PLANNING DIRECTOR'S SPECIAL PERMIT
1231 "I" STREET, SUITE 200, SACRAMENTO, CA 95814

APPLICATION: A. Negative Declaration
B. Planning Director's Special Permit to exceed the 25 percent office use allowed in the M-1 zone by allowing 10,000+ square feet of office in a proposed 24,395+ square foot warehouse building on 2.18+ vacant acres in the Light Industrial (M-1) zone.

LOCATION: 3800 Business Drive (Building A)

APPLC. NO. P90-429

F3 EXTERIOR ELEVATIONS-BLDG. 'A'
1/8"=1'-0"

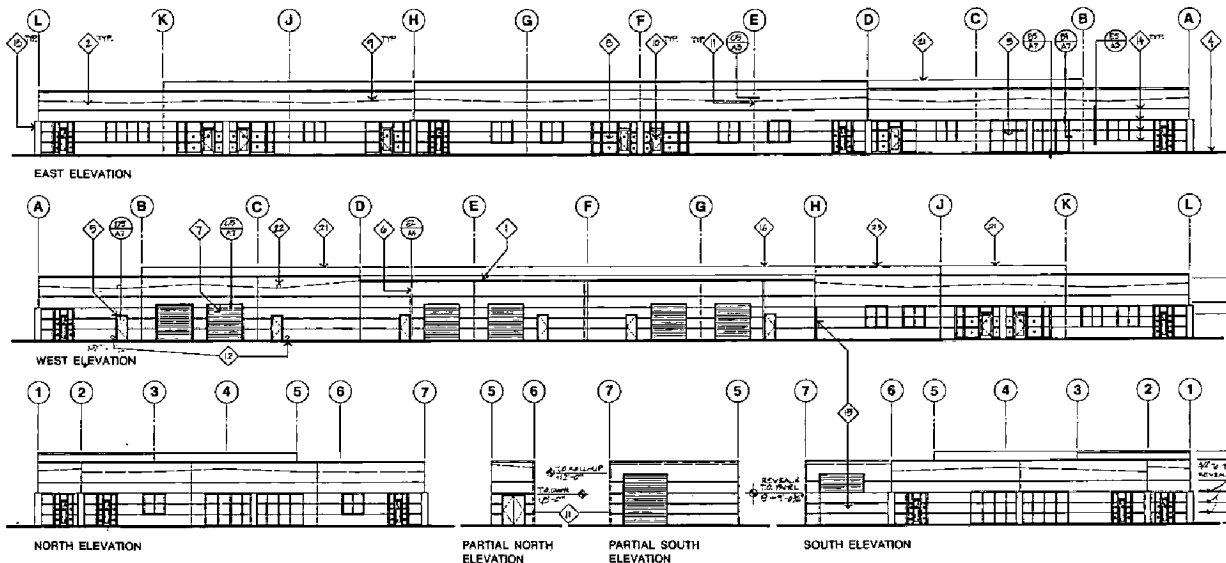
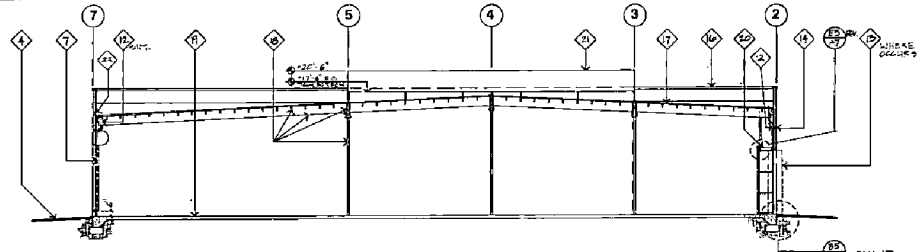
The north, south and east elevations will consist of storefronts of four inch colored, narrow style aluminum sections with solar bronze glazing. The corner entries will be recessed and on an angle. The west elevation consist of storefronts and three sets of loading doors for a total of six loading doors. Two sets of loading doors will be located in a recess area of the building 75+ feet from the west property line. The third set of loading doors will be located on north west portion of the building 37+ feet from the west property line, which conforms to the map condition. Staff has some concerns with the loading area adjacent to residential. Staff suggested to the applicant that the building be flipped in order to protect the residential uses on the west. Staff felt that since this was a warehouse park that the property to the east

would not be harmed by locating the doors on the east elevation. The applicant opposed this recommendation since the owner is proposing to locate his main office east of the site on Lot 9 which is directly across the Business Drive. The applicant suggested recessing the loading doors two feet on the northwest portion of Building A and providing a finger planter between the pairs of loading doors in the recessed area of Building A (Exhibit B). The planters would reduce the size of the trucks that would be able to use the doors as well as provide additional landscaping to break up the expanse of the building. Staff supported these suggestions. A screen wall will be constructed on the west elevation to shield the loading area from the view of 14th Avenue. The building materials will be of pre-cast concrete tilt-up panels with reveal lines. The roofing materials will be a built-up composition roof. Staff recommends the colors should be compatible with the existing buildings located in the area.

1. Any roll up doors on the west wall of the structure shall be placed no closer than 35 feet from the property line and not exceed 10' X 10' in size.

EXHIBIT B

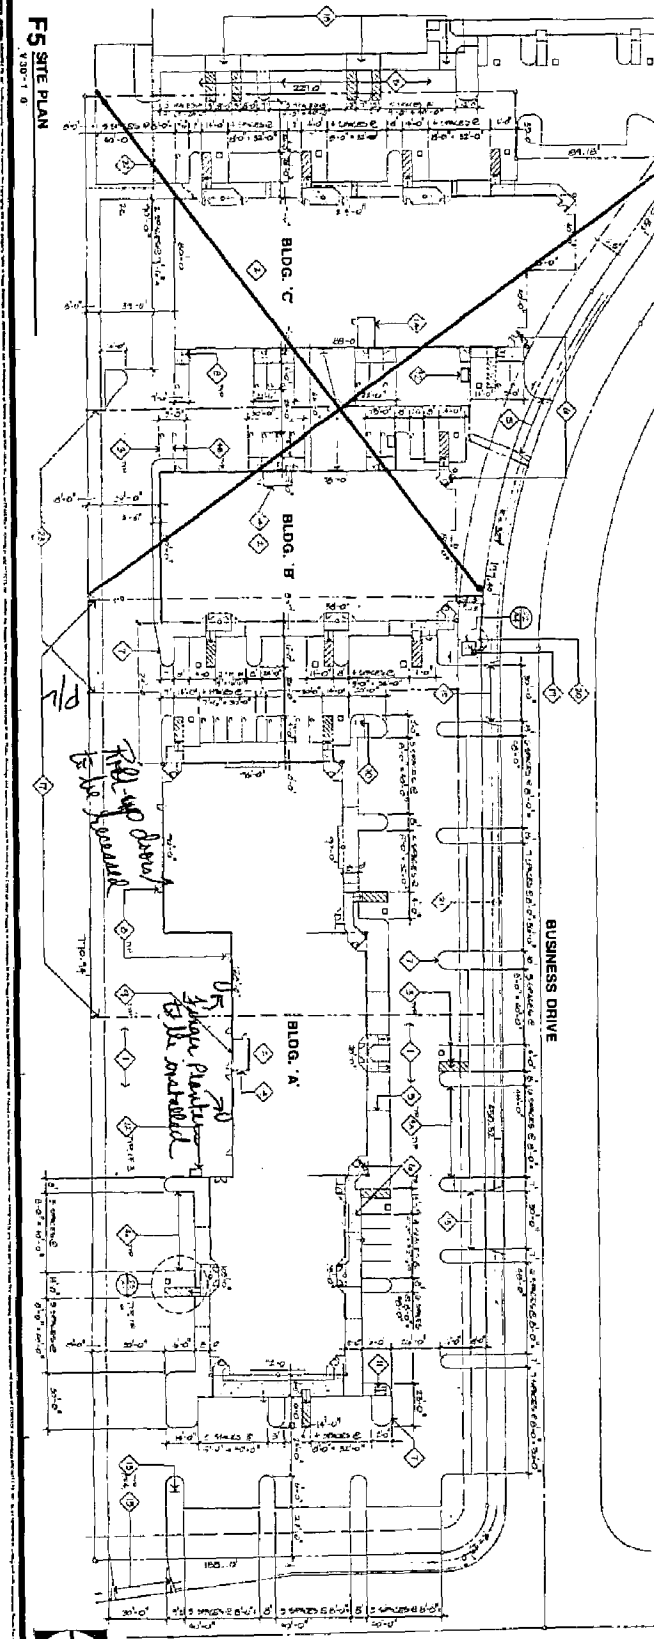
The plans do indicate a driveway located on the northeast portion of the site. This driveway is bisected by the north property line. City Code requires a driveway to be ten feet from a property line. The driveway and parking layout will need to be redesigned or the property line will need to be adjusted in order to meet the City Code requirement. An additional driveway is located on the southwest portion of the site eight feet from the west property line. Staff recommends relocating this driveway 20 feet from the property line since it is adjacent to a single family house which is located 3 feet from the property line. This area will be required to be landscaped.

The submitted plans indicate a dumpster to be located behind the screen wall on the west side of the site. A trash enclosure is required when a dumpster is used. The trash enclosure must meet the requirements of the Zoning Ordinance. Staff recommends that the trash enclosure not be located within the 25 feet building setback along the west property line.

Traffic Engineer - The driveway shall comply with all sections of the City's driveway ordinances to include but not limited to the requirement that driveways shall be located ten feet from a property line.

Relocate proposed driveway on 14th Avenue out of the flared section and minimum 10 feet from property line.

The adjacent property owners were notified of the proposed increase in office space. The property owner on 14th Avenue adjacent to the site objected to the location of the driveway. He wished to see the driveway relocated to reduce noise generated by large trucks using the driveway.

2. The driveway on Business Drive shall be redesigned to the satisfaction of the Traffic Engineer and comply with the City Code which requires driveways to be located a minimum of 10 feet from a property line.

3. The driveway on 14th Avenue shall be relocated 20 feet from the west property line.
4. A 25 foot landscaped setback along the 14th Avenue frontage shall be provided. Landscaping and irrigation plans shall be approved by the City Landscape Architect prior to issuance of building permits.

5. A trash enclosure which meets the requirements of the Zoning Ordinance must be provided. This trash enclosure shall not be located within the 25 foot non-buildable setback easement along the west property line.

10. The loading doors located on the northwest portion of the building shall be recessed a minimum of two feet per Exhibit B, subject to review and approval of the Design Review staff.

11. Two finger planters shall be constructed between the two sets of loading doors on the west elevations per Exhibit B, subject to review and approval of the Design Review staff.
